Draft proposal for amendments to UN Regulation No. 43 (Safety glazing)

This document was prepared by the informal group on the introduction of plastic glazing for windscreens and laminated plastic panes other than windscreens in UN Regulation No. 43 (IGPG). It supersedes the informal document GRSG-104-43. The modifications to the current text of the Regulation are marked in bold or strikethrough characters.

I. Proposal

Annex 1, Appendix 13 (former Appendix 10), amend to read:

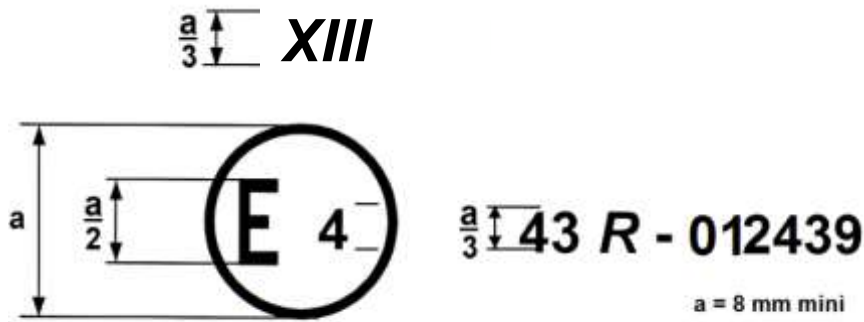
R-point coordinates (A, B, C) relative to the center of the upper edge of the windscreen.

"Rigid plastic windscreens"

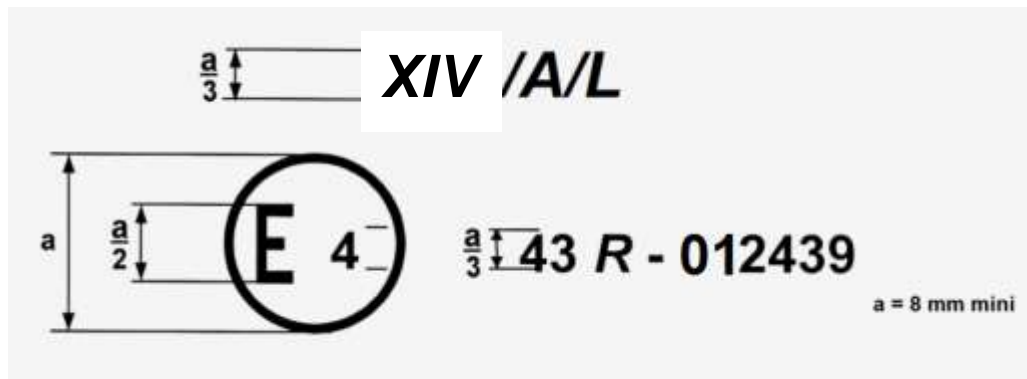
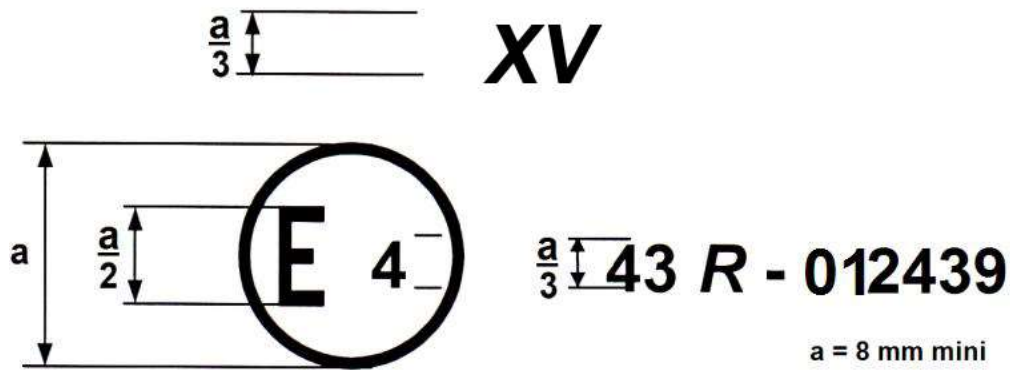
Annex 2, insert the following new paragraphs at the end of the Annex:

The above approval mark affixed to a rigid plastic windscreen shows that the component concerned has been approved in the Netherlands (E 4) pursuant to Regulation No. 43 under approval No. 012439. The approval number indicates that the approval was granted in accordance with the requirements of Regulation No. 43, as amended by the 01 series of amendments.

The above approval mark affixed to a laminated rigid plastic glazing pane for forward facing panels with a light scatter not exceeding 2 per cent after 1000 cycles (in case of Taber test) on the outer surface and 4 per cent after 100 cycles on the inner surface shows that the component concerned has been approved in the Netherlands (E 4) pursuant to Regulation No. 43 under approval No. 012439. The approval number indicates that the approval was granted in accordance with the requirements of Regulation No. 43, as amended by the 01 series of amendments.

Figure 6
Sand drop equipment

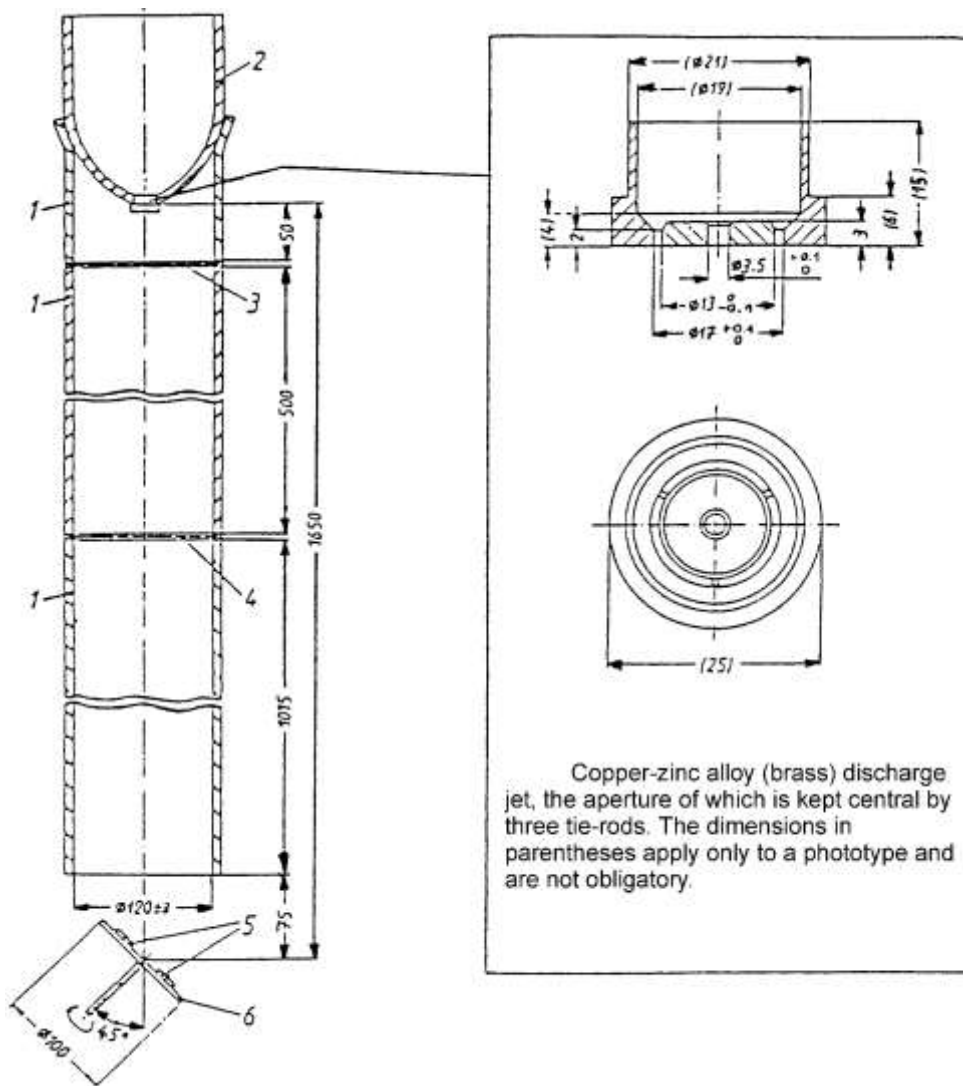
Annex 3, insert a new paragraph 4.7. and a new Figure 6, to read:

4.7. Sand Drop Test

The sand drop test equipment shall consist essentially of that illustrated in Figure 6. The gravity tube consists of three separate rigid polyvinylchloride tubes (PVC hard) of the same diameter, with two polyamide sieves mounted in between. The sieves should have a mesh size of 1.6 mm. The speed of the turntable shall be 250 ± 10 rpm.

Figure 7
 Movement pattern of washing brush and nozzle

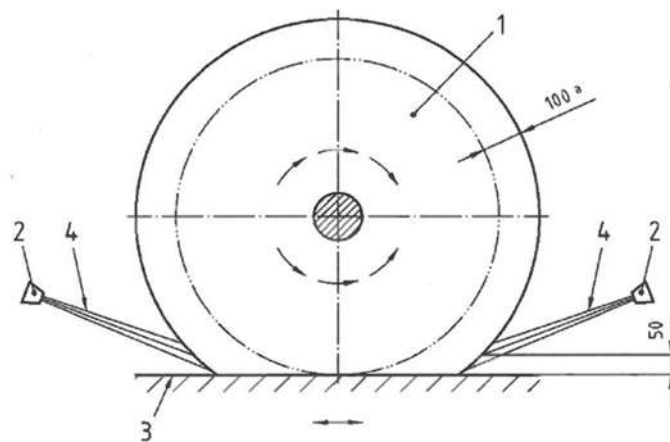
Annex 3, insert a new paragraph 4.8. and new Figures 7 to 10, to read:

diameter	(1 000 ± 40) mm
width Minimum	300 mm
rotation speed	(127 ± 5) min-1
brush rotation	rotates in the opposite direction relative to the direction of travel of the test panel holder
material	polyethylene
bristle profile	x-shaped, spliced
bristle thickness	(0.8 ± 0.2) mm
bristle length	(440 ± 20) mm visible
penetration depth	(100 ± 20) mm (see figure 7)

Figure 8
Calibration arrangement

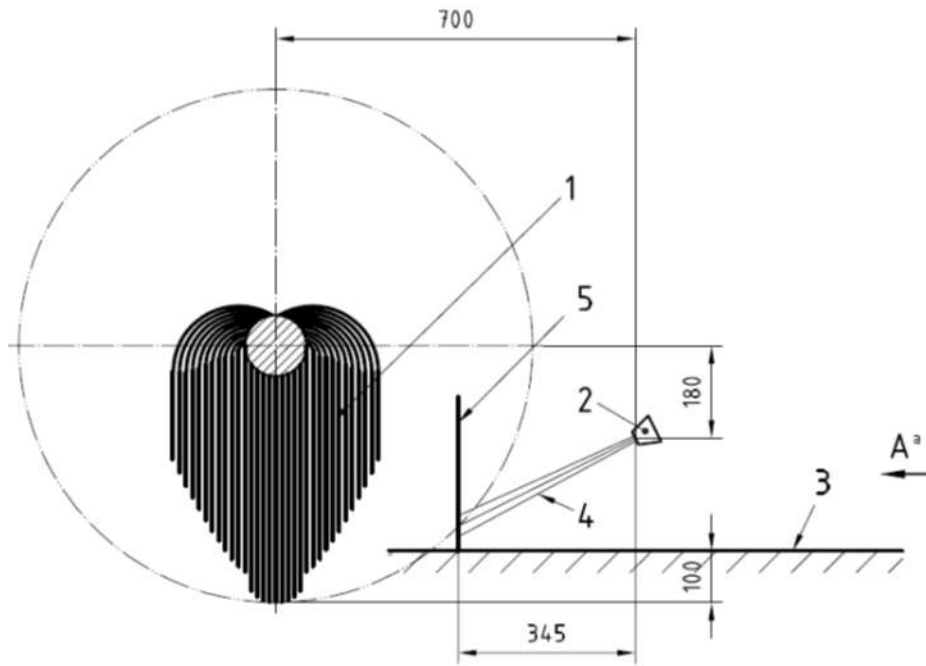
4.8.4.1.3. Do the instrument calibration as follows: Set up the equipment as shown in Figure 8. Fill with washing suspension (see paragraph 4.8.2. of this annex and wet the brush sufficiently. Determine the flow rate of the water, (2.2 ± 0.1) l/min, by measurement and adjust by altering the pressure, (300 ± 50) kPa. Check the spray pattern of the nozzles (see Figure 9) If the spray pattern cannot be

Figure 10

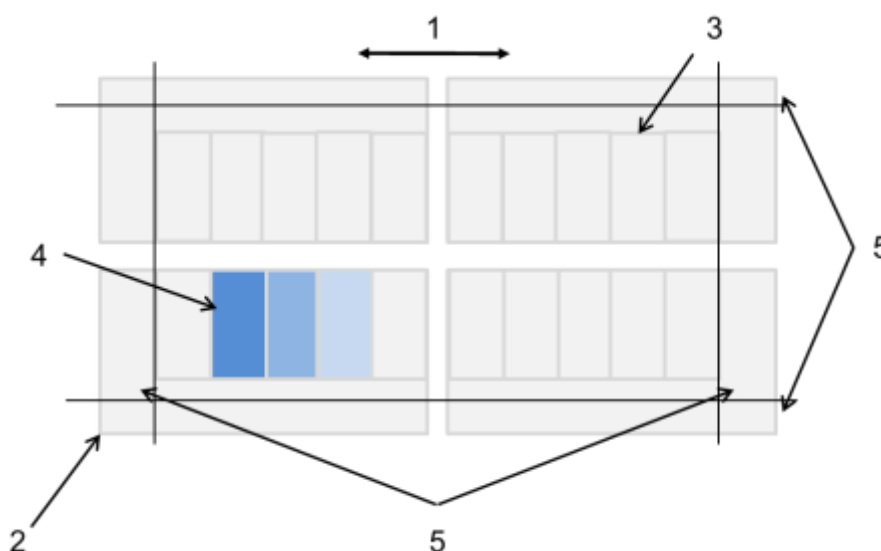
4.8.4.2.1. Affix the samples with the outside surface face up onto a supporting plate by using a double-faced adhesive tape (Sample positioning on the test holder as shown in Figure 10).

Figure 11
Cross-section view of the apparatus

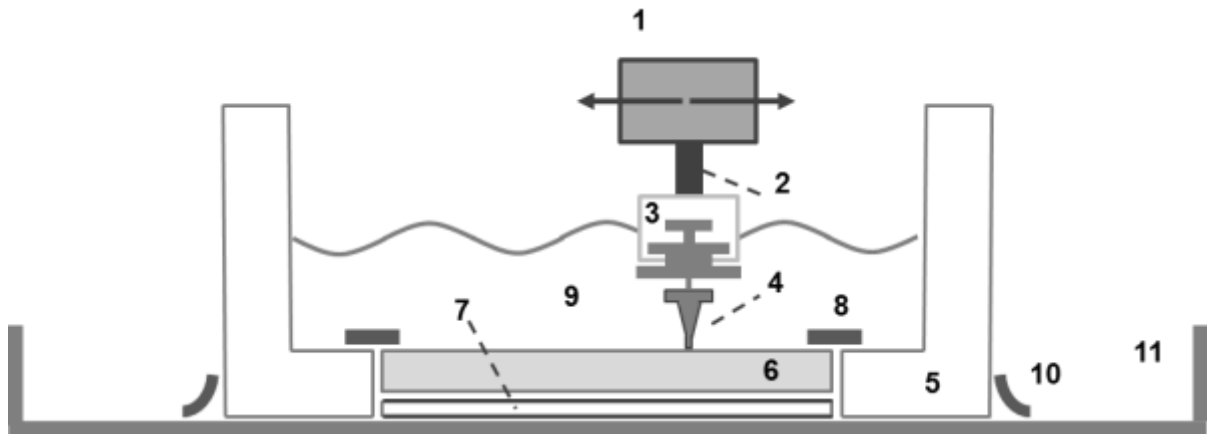
Annex 3, insert a new paragraph 4.9. and new Figures 11 to 16, to read:

- 4.9.1.2.** a wiper carriage assembly (see 1 in the figures 11 and 12) having a beam which spans across the width of the base apparatus and can be mounted at its ends to the pillars, furthermore this carriage assembly has two self-supporting arms (see 2 in the figures 11 and 12) where a wiper holder can be attached (the distance between the sample surface and bearing of self-supporting arm at the carriage assembly is 100 to 105 mm)

- 4.9.1.3.** a wiper holder² (see 3 in the figure 11) suitable to attach a normal wiper blade (see 4 in the figure 11) and adjusted to provide a load of $15 \pm 0,5$ g/cm (the weight of the wiper blade and its holder together with the wiper blade width determine the wiper load in g/cm)

- 4.9.1.4.** two sample boxes³ (see 5 in figure 11 and 12) made out of inert, material in the interior dimension of 200 mm x 120 mm (50mm height) used to be filled with the aqueous suspension and having a hole at the bottom⁴ where the test sample can be inserted and therefore used as a test sample holder

Figure 13

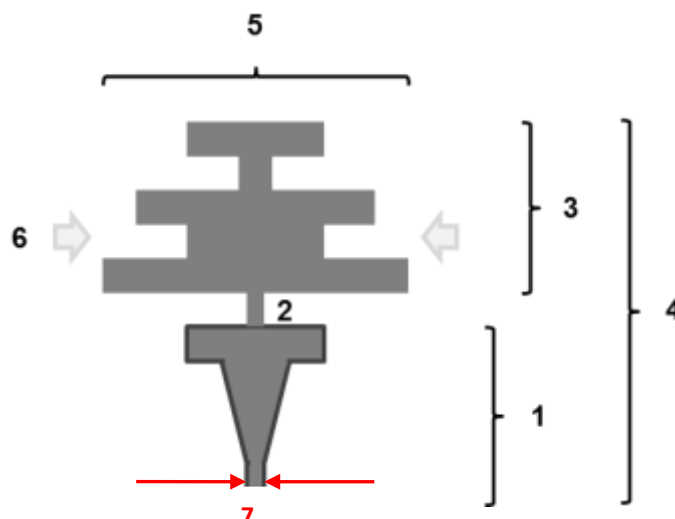
- a normal glass windscreen wiper blade based on chloroprene type rubber (CR grade), chlorinated and with a graphite based anti-friction coating on the surface with a cross profile as shown in figure 13⁶ in a width of 80 mm or
- a commercially available specific device which is adjusted to the surface characteristics of the rigid plastic glazing and actually intended to be used in the vehicle (e.g. a hydrophobic wiper blade) also in a width of 80 mm. The geometric, physical and chemical characteristics (e.g. hardness, coating composition and thickness

Figure 14

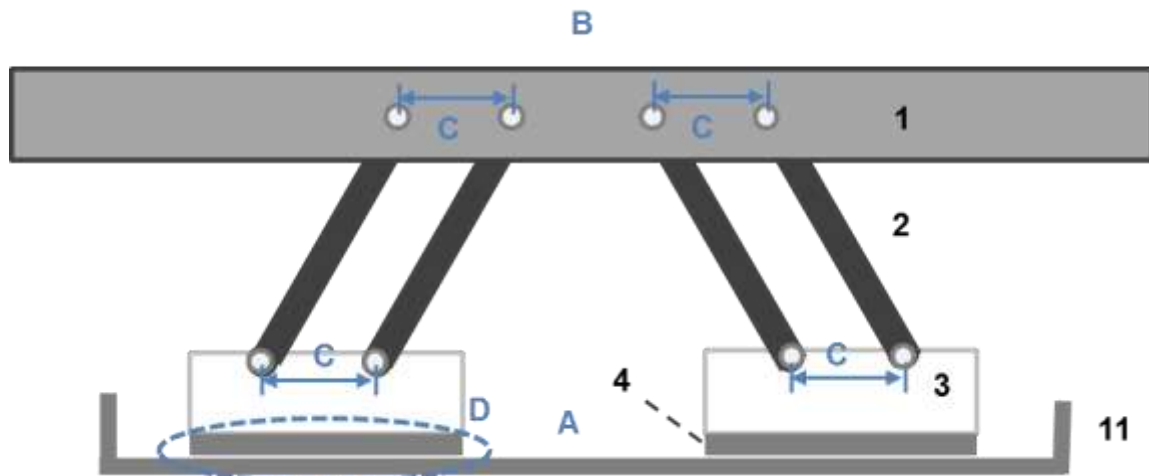
4.9.5.2.2. Build up the whole instrument including tray, wiper carriage assembly, wiper blade holders and new wiper blades but without sample box and sample (see Figure 14). To do so the two new wiper blades shall be mounted to their respective wiper blade holders and the latter ones shall be fixed to the carriage assembly. Then align using a spirit level the base plate where later the sample box will be placed and the wiper carriage assembly. Check that the distances of the two bearings of both self-supporting arms at the wiper carriage assembly and at the wiper blade holder are identical. Furthermore control visually that the wiper blade rest on the base plate uniformly without losing contact to the base plate at any point of the wiper blade.

Figure 15
Rearrangement of the sample boxes

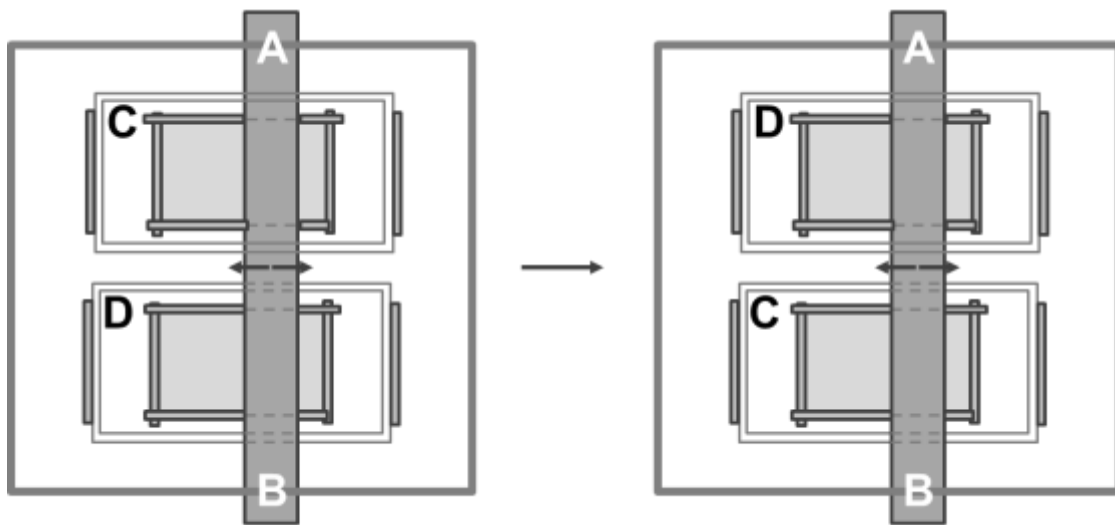
- 4.9.5.3.6. In order to ensure a homogenous abrading it is necessary to follow the action described below:
- 4.9.5.3.6.1. after half of the test cycle numbers ([10.000 cycles]) the test shall be stopped and the two sample boxes shall be exchanged without turning them (see figure 15)¹⁰; this leads to an exchange for the two simultaneously tested samples regarding their wiper blades and furthermore alters the alignment of the self-supporting arm carrying the blade (from left to right or the other way round).

Figure 16
Measurement points across the sample

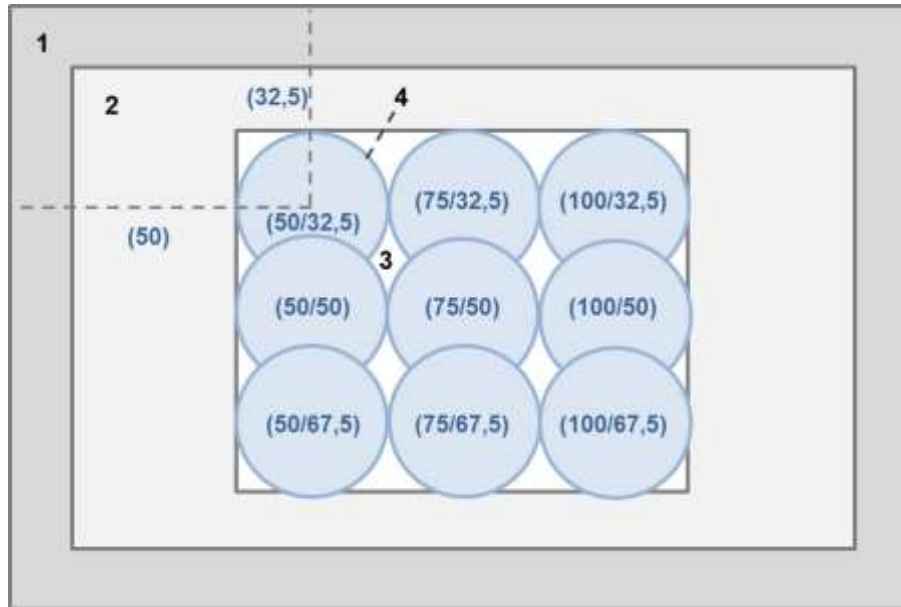
4.9.5.4.4. 9 measurement points according to the figure below shall be used to determine the delta haze at these points and calculate an average delta haze afterwards.

Design Drawing of the Wiper Blade Holder

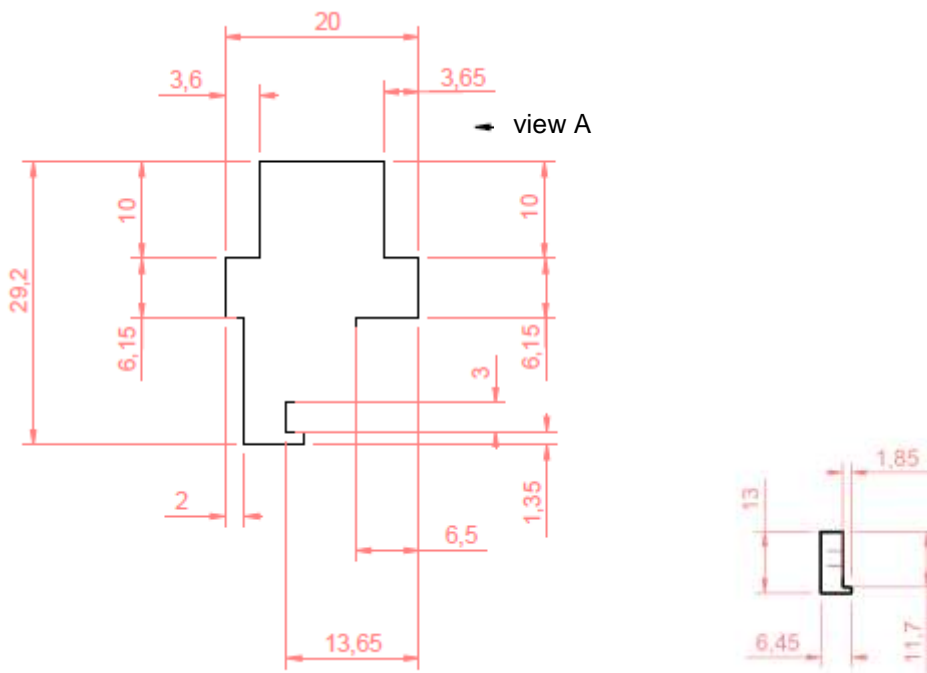
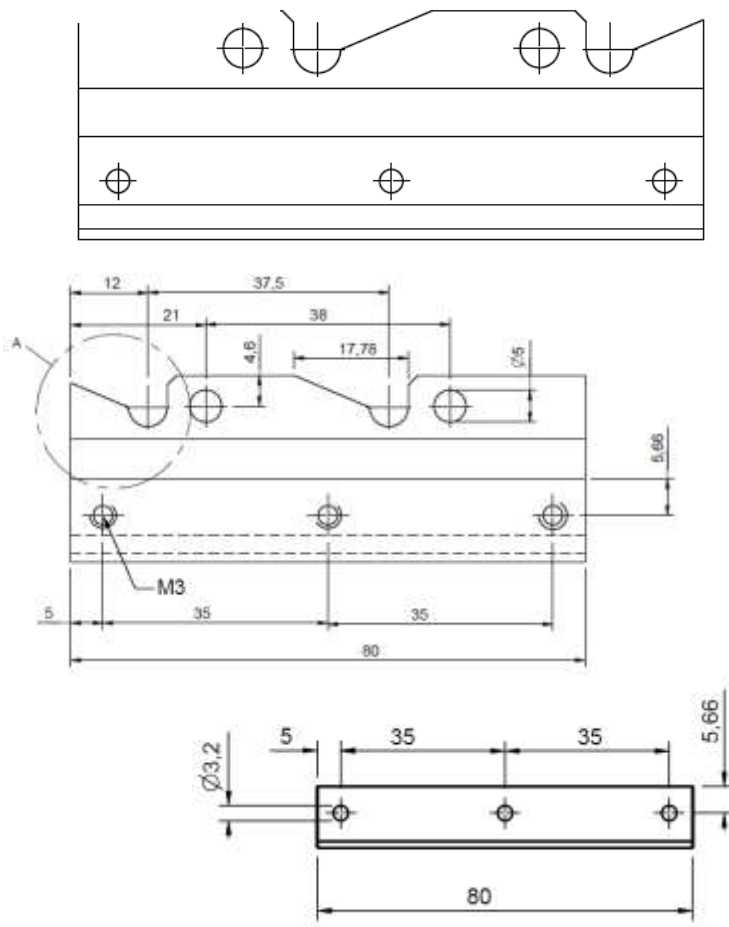
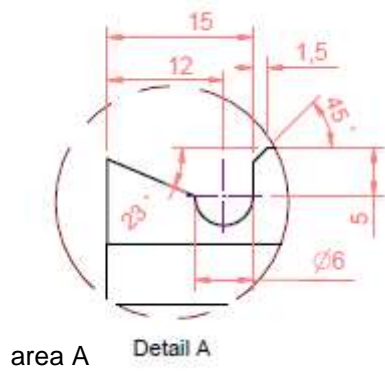
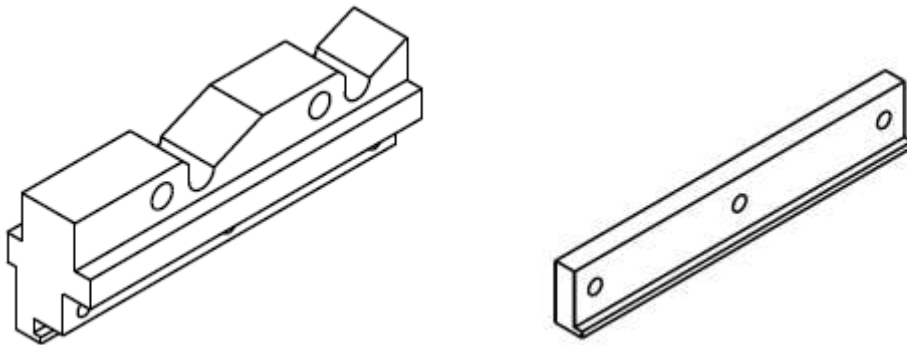
Annex 3, insert new Appendix 1, to read:

Design Drawing from the Sample Box

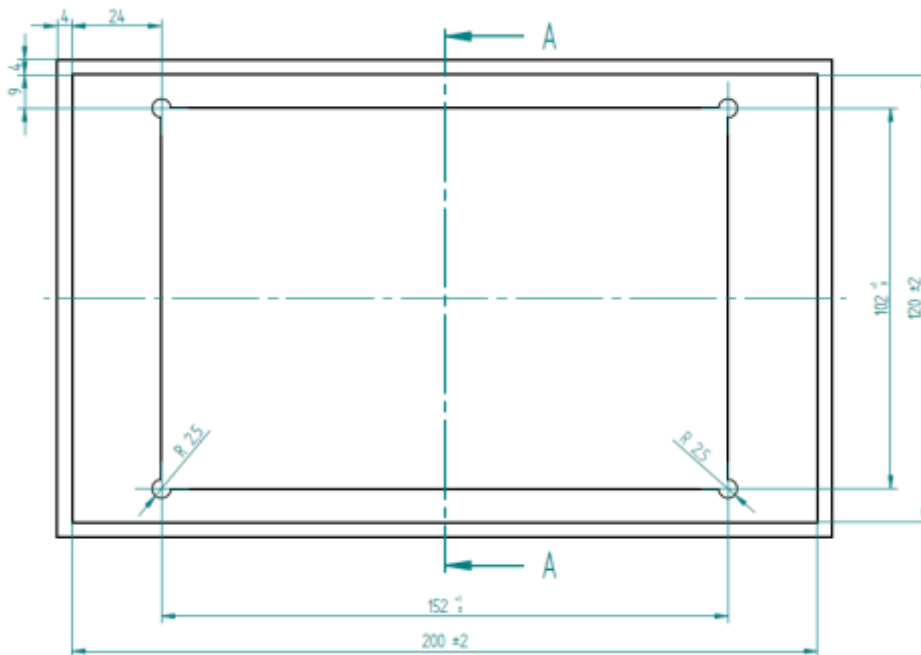
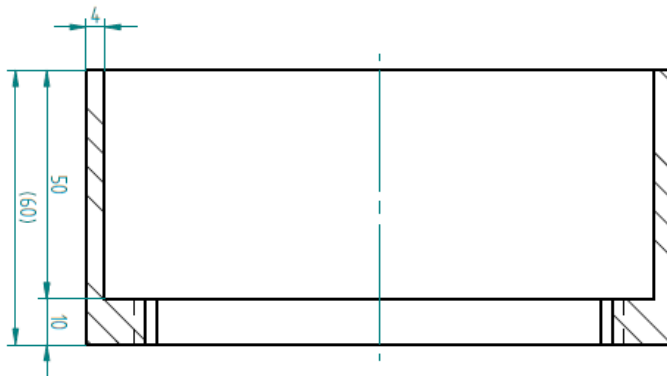
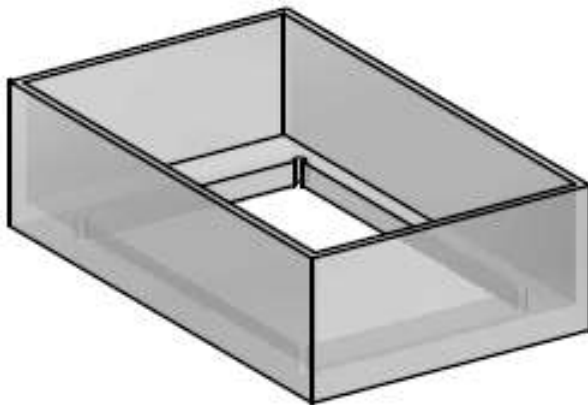
Annex 3, insert new Appendix 2, to read:
